Pavillion Gas Well Integrity Evaluation

U.S. Environmental Protection Agency Region 8

July 25, 2013

Figure 1 and definitions (from Schlumberger)

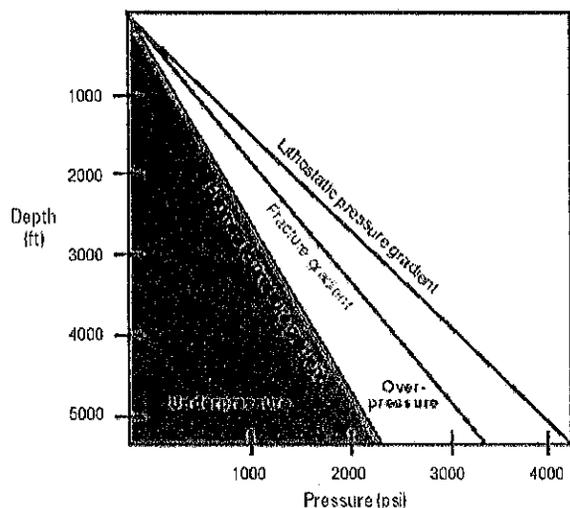
The difference between the line defining the fracture gradient and the line defining the hydrostatic pressure gradient is a zone referred to as overpressure. This is the area in yellow and demonstrates that if you have overpressure zones and zones at or below the hydrostatic pressure zone in red that open to the same well bore annulus, migration of fluids can occur. This is true during drilling and after the well casing strings have been cemented. If all of the zones open to the well bore annulus lie on the hydrostatic pressure gradient then theoretically no fluid flow would occur. However, zones with

pressures that fall within the yellow would pose a potential flow if there are also zones that follow the hydrostatic gradient or are in the red underpressured zone that are open to the un-cemented annulus

Figure 2 (from Harrison 1985)

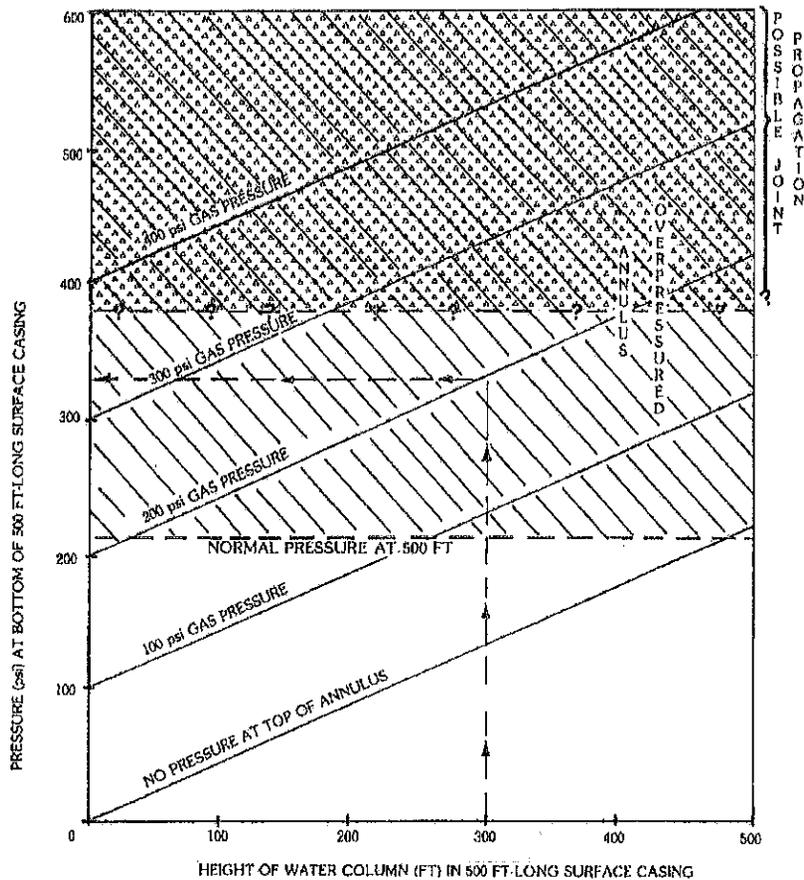
Figure 2 represents an example for a 500 foot depth surface casing demonstrating that overpressure in the annulus causing gas or liquid migration occurs at pressure less than a calculated fracture pressure for this hydro-geologic setting and is dependent on gas pressure and the hydrostatic pressure or height of the water column in the bradenhead annulus. In Figure 2 if it was determined that the liquid was

drilling mud and not water, the calculation could use 0.47 psi/ft for 9ppg mud could be used instead of 0.433 psi/ft for water.

Figure 3

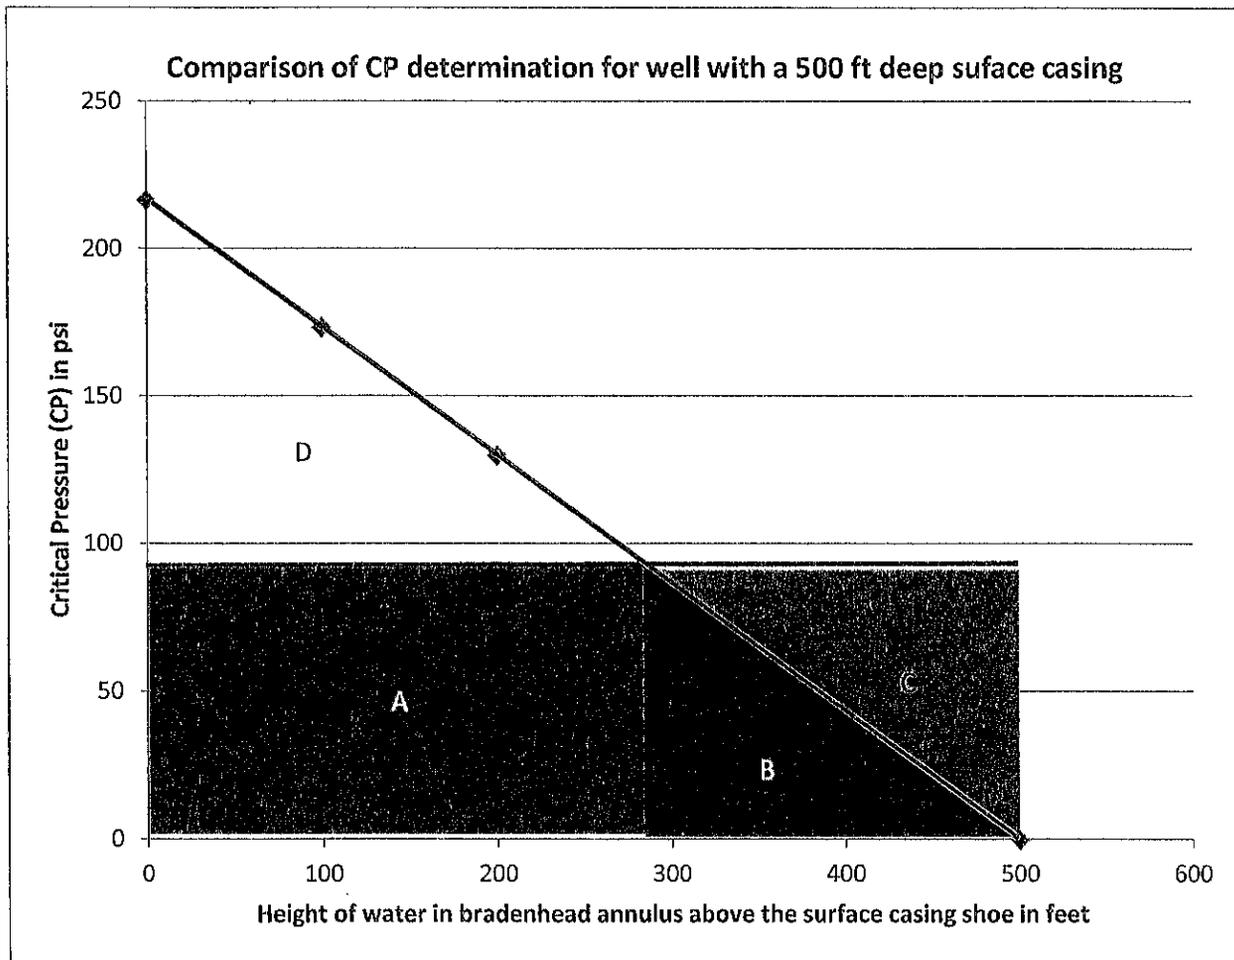
Area A represents acceptable pressure values using fracture gradient CPf (90 psi). Area B represents acceptable pressure values using hydrostatic head above the surface casing shoe CPop

Red line represents a CPf of 90psi calculated using the Encan proposal. The black line represents critical pressure based pore pressure of formation at 500 ft and the head of liquid above the surface casing shoe. As the head of fluid in the bradenhead annulus increases the allowable critical pressure value (CPop) in the bradenhead annulus decreases. Where the two lines intersect the critical pressure would decrease from 90psi along the gradient represented by the black line.

Area C depicts pressures less than the calculated critical pressure based on fracture pressure gradient but the pressure would be greater than the critical pressure based pore pressure of formation at 500 ft and the head of fluid above the surface casing shoe

Area D could represent the possibility that pressure values within this area (above the calculated frac gradient critical pressure) may be too conservative and mitigation may not be necessary.

One proposal could be to use a combination of the methods where pressures within areas A and B would be less than the critical pressures determined by both methods.
